# Technical Bulletin

HAMMOND ORGAN

January 12, 1967  
NO. MODELS

SUBJECT: SWITCHING TRANSIENT ("E" SERIES)  
IMPROVED BASS RESPONSE (H-100)

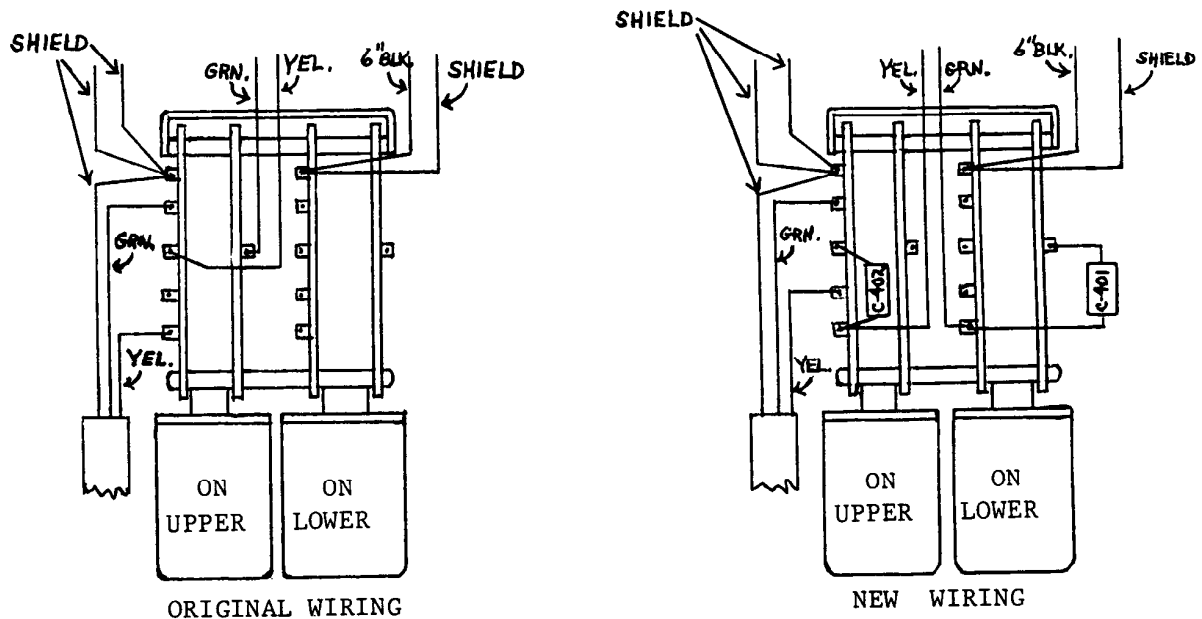
To relieve the above condition in the "Vibrato On" switches on "E" series instruments, we recommend rerouting the Yellow and Green wires going to the preamplifier, as indicated in the diagram below. To complete the circuit it will be necessary to add condensers; C-401 and C-402, .039 MFD/100 volts as indicated in the diagram below.

The drawing on the left represents the original wiring method, while the drawing on the right represents the above changes.
